**TO:** Design Review Commission  
**FROM:** Calandra Niday, Assistant Planner  
**SUBJECT:** SC19-0010 – 126 Mount Hamilton Avenue

This is a design review application for a new two-story house. The proposed project includes 2,740 square feet on the first story, 1,206 square feet on the second story, and a 2,704 square-foot basement. This application was previously reviewed by the Design Review Commission on October 2, 2019 and April 15, 2020. The following table summarizes the project's technical details:

**TO:** Design Review Commission  
**FROM:** Calandra Niday, Assistant Planner  
**SUBJECT:** SC19-0010 – 126 Mount Hamilton Avenue

STREETSCAPE  
CONTEXT

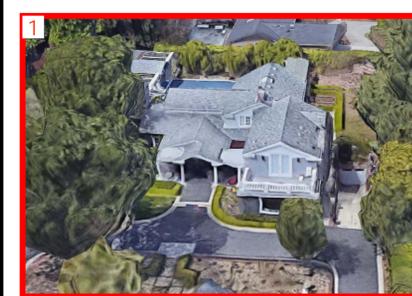
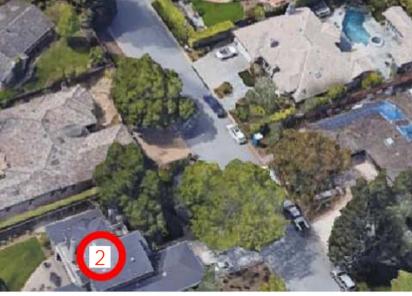
**Provide a streetscape image of the house with one house to the left and one to the right in order to evaluate the house in its context.**

Front Elevation / October 2019

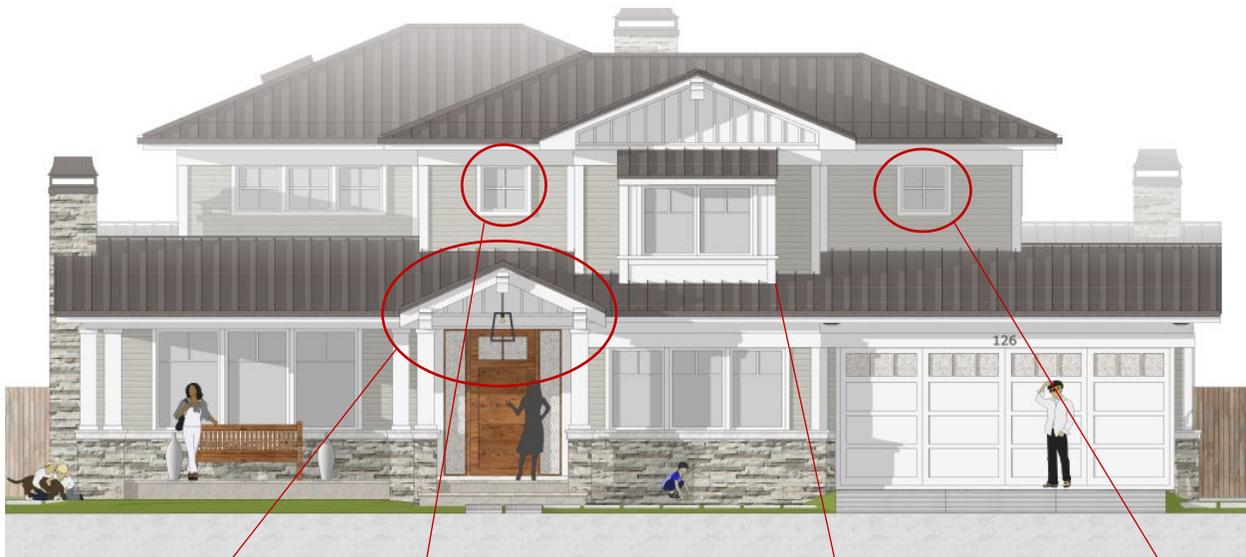
To help reduce the visual bulk and mass of the second story, the applicant lowered the height of the front entry feature which allowed the second story wall above the entry to be pushed back 4.2 feet. Lowering the front entry element resulted in a front gable that is included as part of the horizontal eave line across the front elevation, which is consistent with the eave lines of the neighboring properties. The visual mass of the second story was also reduced by pushing back Bedroom #2 by 3

To reduce any privacy concerns, the glazing on the front and side elevations has been minimized. The amount of front facing glazing has been reduced by changing Bedroom #3 to be rear facing and moving the bay window from the front elevation to the rear elevation. The windows on the right side (west elevation) was reduced from five windows to four windows with sill heights of 4.2 feet and 6.6 feet. A visual representation of the project modifications is included in Attachment E. The second story side yard setbacks on the right side was increased from approximately 22.8 to 23.8 feet which exceeds the minimum standard of 17.5 feet. Overall, due to the increased setbacks and window sill heights, combined with the existing mature trees and extensive evergreen screening proposed along the side and rear property lines, the privacy impacts should be minimized and not considered unreasonable.

October 2019

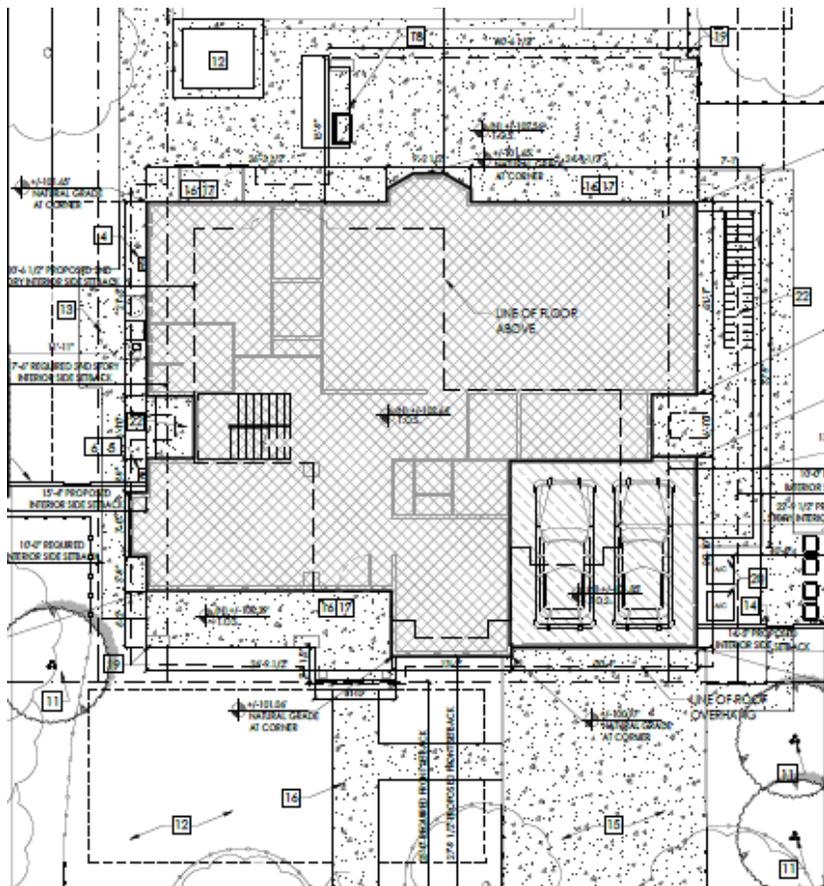
The decrease in the second story massing is further shown in the above front roof perspective.

West Elevation (Right Side) / October 2019

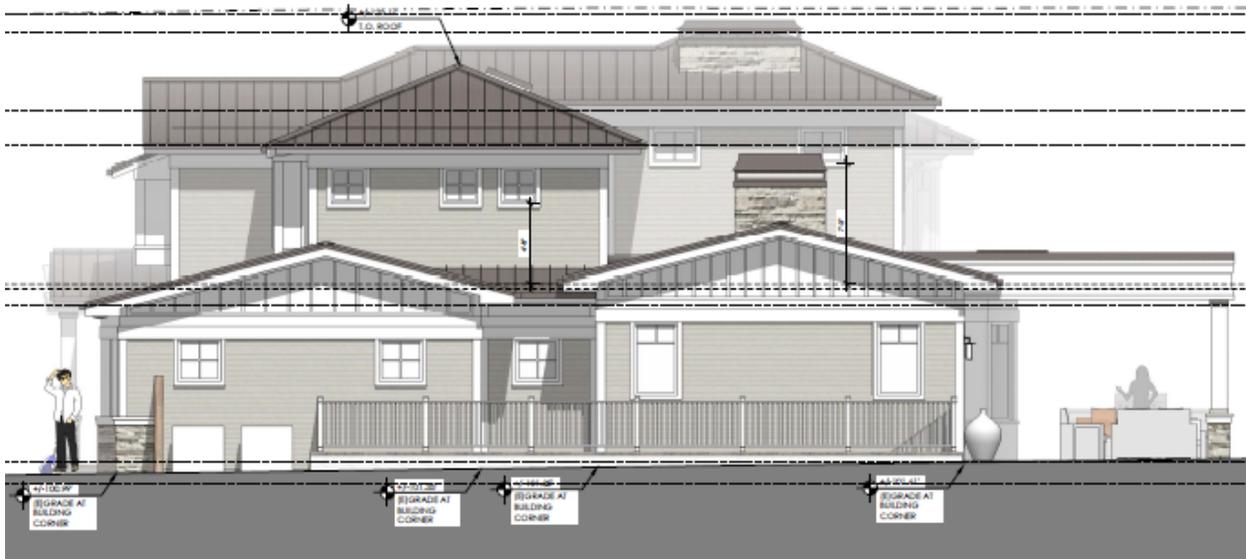
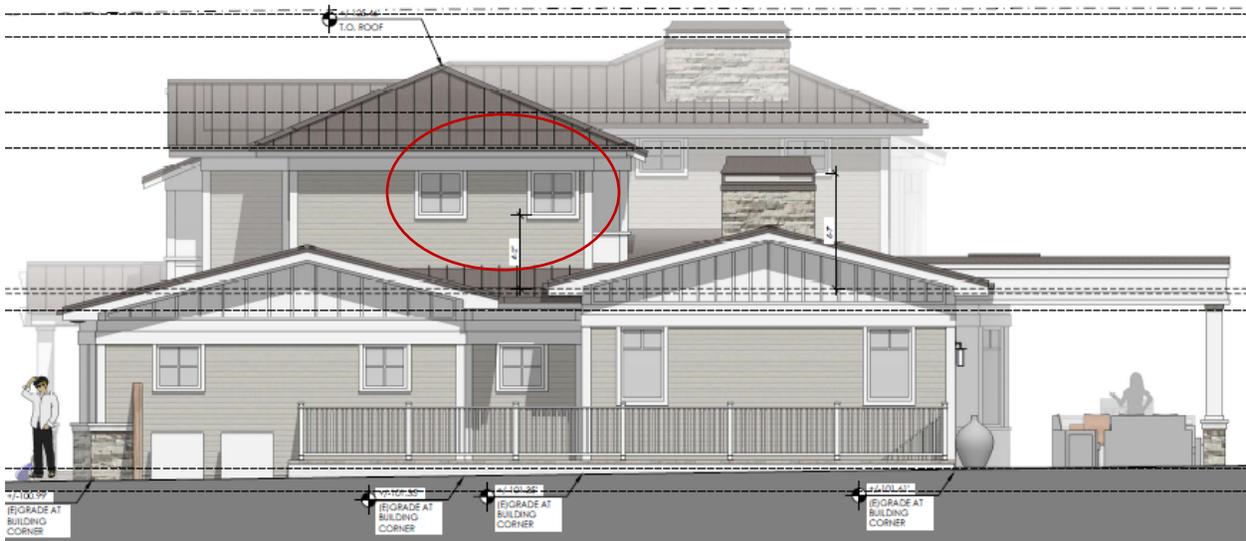
**Modification: The number of windows on the West Elevation was reduced; the second story side setback was increased to 23.8 feet, where 17.5 feet is required in a R1-10 District.**

Rear Elevation / October 2019

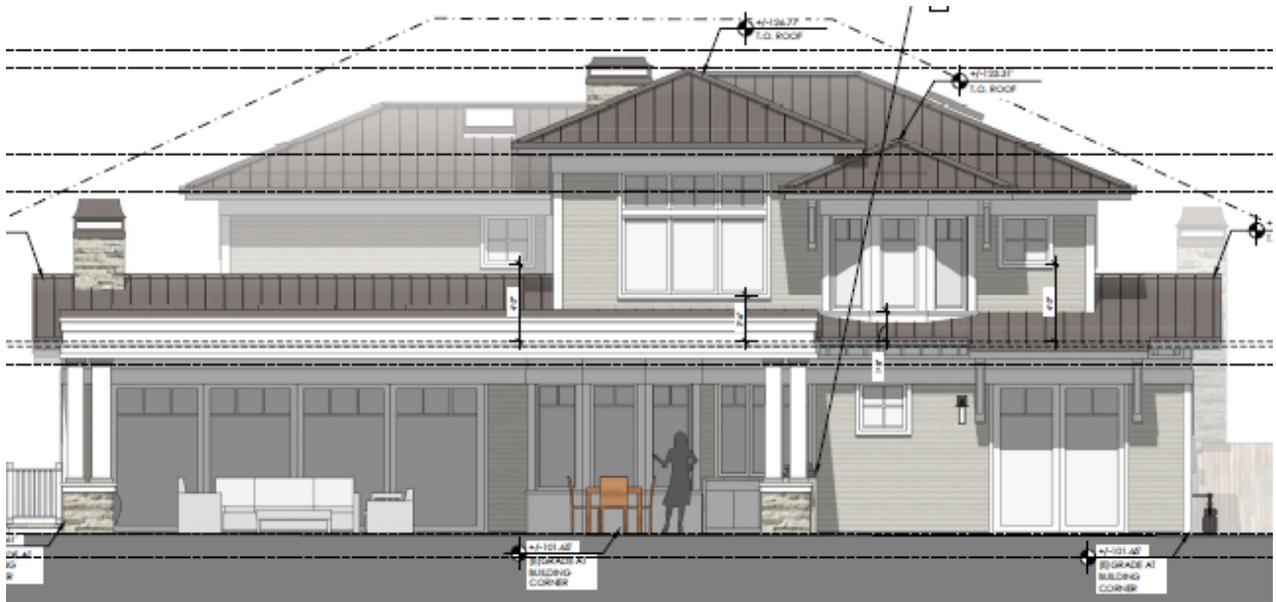
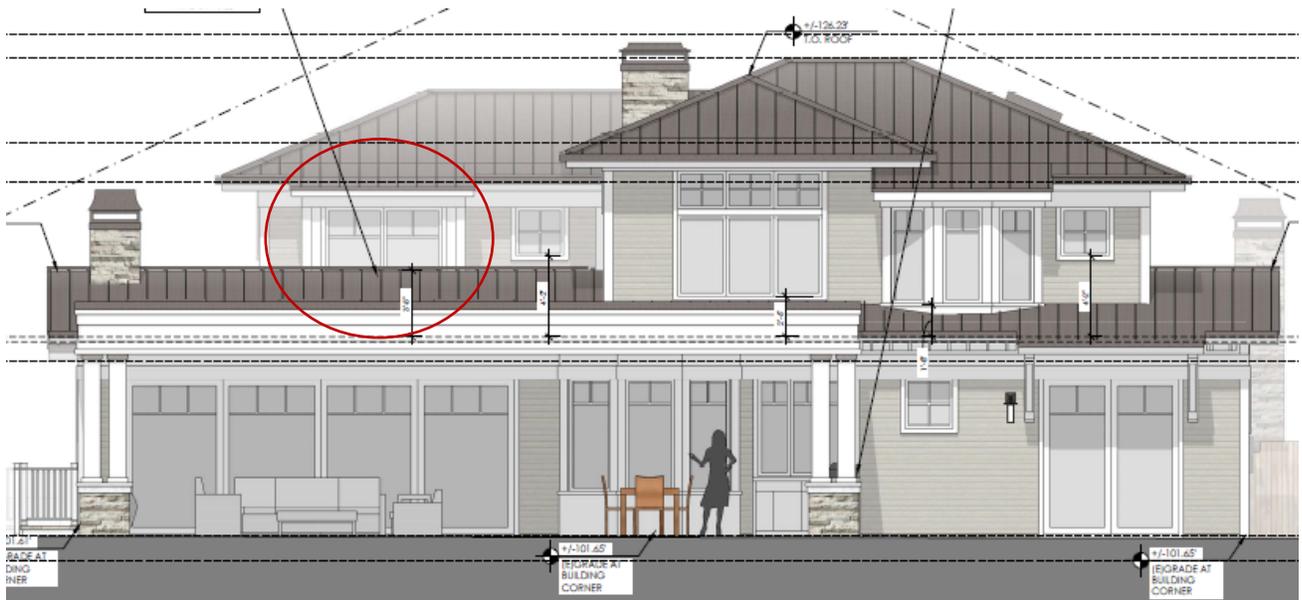
**Modification: The bay window in Bedroom #3 was moved to the rear elevation; however, the project proposed an increased rear yard setback of approximately 52.4 feet, where a setback of 25 feet is required in a R1-10 District.**

East Elevation (Left Side) / May 2020

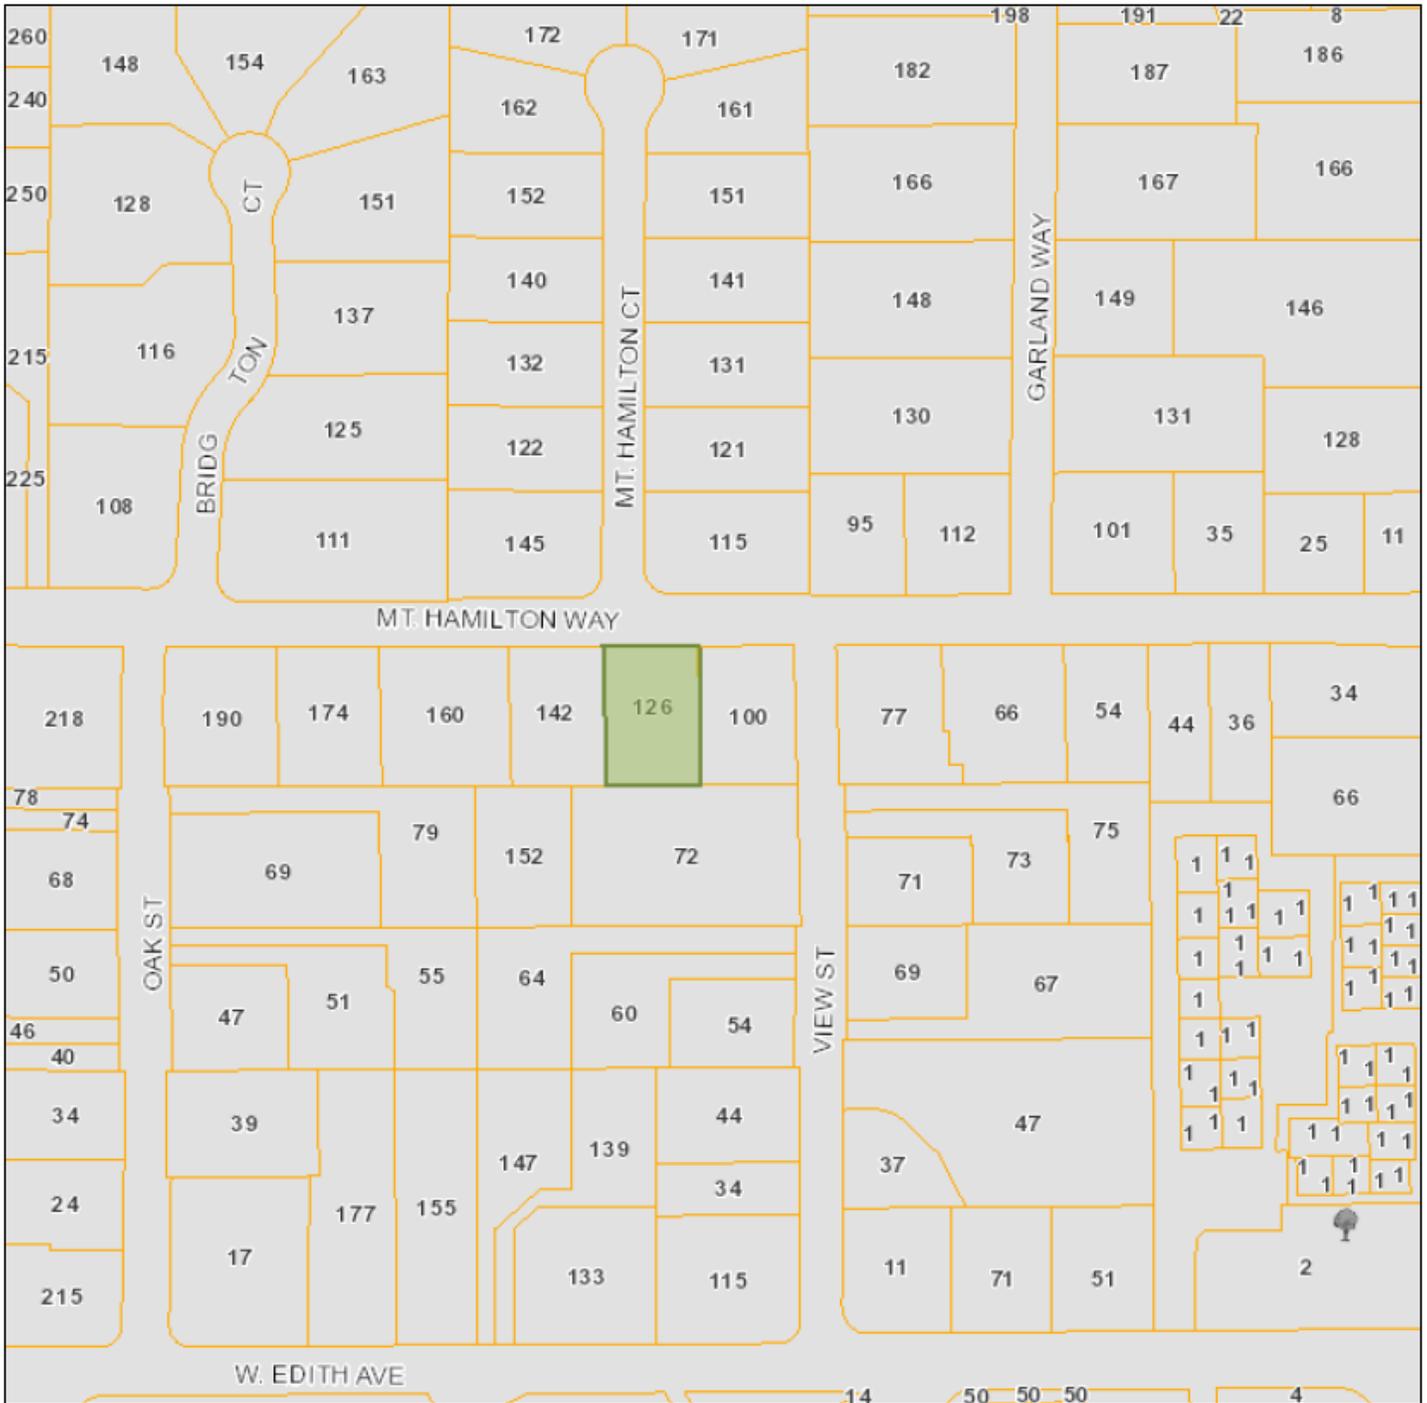
**On the East Elevation, there are no major changes on second story in regards to massing and privacy.**
